SERVICE BULLETIN	
Service Bulletin #	AASB-1-1-2011
Superseded Bulletin #	n/a
Issue Date	1-31-2011
Effective Date	1-31-2011
Limitations for Completion	Next scheduled inspection
Make & Model Affected	Lightning LS-1 SLSA & ELSA
	SN87 thru 107
Page 1 of 3

1. Applicability: Lightning LS-1 SLSA or ELSA aircraft in the effected serial range of SN87 thru SN107.

Figure 3: Compression tubes added V2

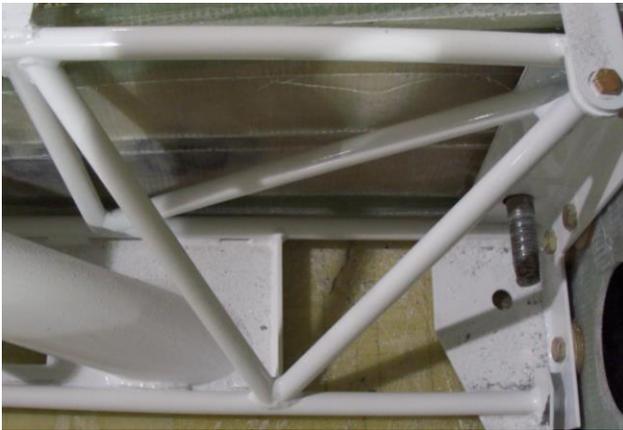
2. Background: Aircraft in the above serial number range were manufactured with a rear spar box V1 , which if landed hard enough or landed over the 1320lbs gross weight limit on SLSA aircraft may deform at the gear attach points. Static testing of the structure per ASTM standards showed no deformation when loaded to the max landing loads, however it has been noted in the field that the spar box has on rare occasions deformed. The deformation of the rear box has been limited to the gear attach point and does not appear to cause an issue with the spar truss carry thru, thus not requiring immediate action. Damaged rear spar boxes were examined and a solution to prevent the deformation has been devised. The addition of compression tubes starting at the gear socket plate which run to the upper cross members have been added. In addition a gusset across the socket plate has been added to prevent it from deforming. In no cases have the spar box gear attach points failed.
